ADDENDUM TO H-58-10-AMAM-11

COLLECTIVE FRICTION CLAMP

CORRECT PART INSTALLED

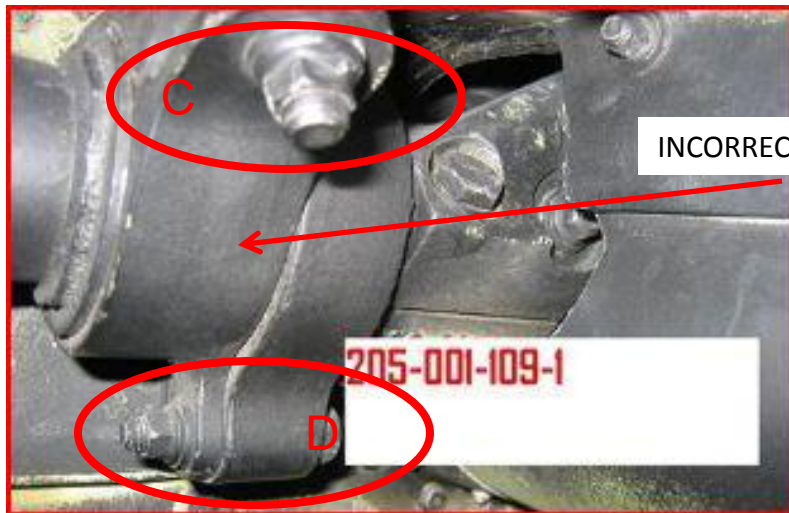
NOTE IN THE CORRECT PART THERE IS APPROXIMATELY 45 DEGREES BETWEEN THE "CLAMPING BOLT" (INSET A) AND THE "MOUNTING BOLT" (INSET B).

Note on the correct Clamp there is only about 45 degrees between the clamping bolt (inset A) and the mounting bolt (inset B).

INCORRECT PART INSTALLED

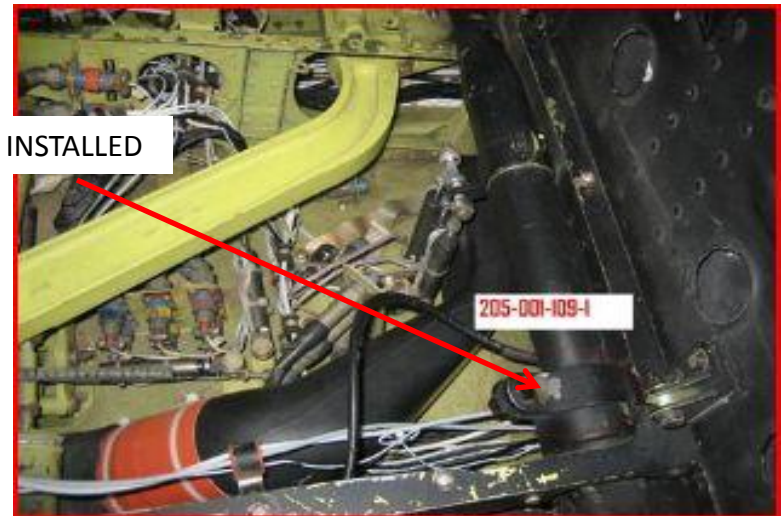
NOTE ON THE INCORRECT PART THERE IS APPROXIMATELY 90+ DEGREES BETWEEN THE "CLAMPING BOLT" (INSET C) AND THE "MOUNTING BOLT" (INSET D).

On the old Clamp, there is approximately 90+ degrees between the clamping bolt (inset C) and the mounting bolt (inset D).
